Proposal for the 03 series of amendments to UN Regulation No. 67 (LPG vehicles)

The text was prepared by the expert from Turkey. It proposes amendment to UN Regulation No. 67 on LPG vehicles to **insert new provisions on the location on the vehicle of the filling unit.**

Problems during filling with various application under the vehicle:

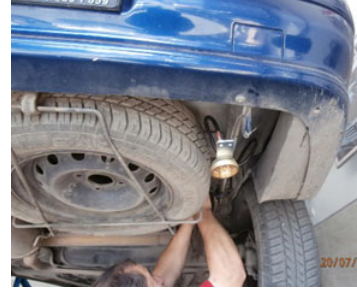
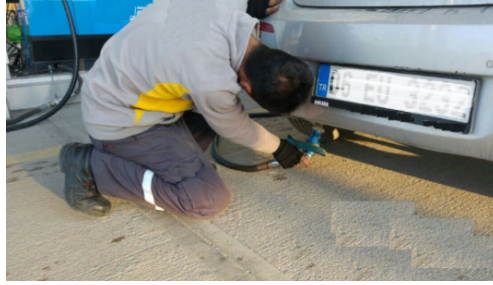
1. In the current text of UN Regulation No. 67, there are no provisions on the location of the filling unit of the LPG container outside the vehicle. The filling unit located under the vehicle causes problems including:
 - (a) Difficulties with filling the LPG container;
 - (b) Risks involved on occupational health and safety of LPG container filling operators;
 - (c) When filling the container, obliges operators to kneel down/lie down on the ground;
 - (d) When the vehicle is in laden position, the filler pistol maybe unable to fit the space between ground and filling unit and prevents the filling of the container.

"6.15.10.8. For vehicles of category M1, the filling unit shall not be located below the body of the vehicle and shall respect the height provisions of paragraph 17.4.5.
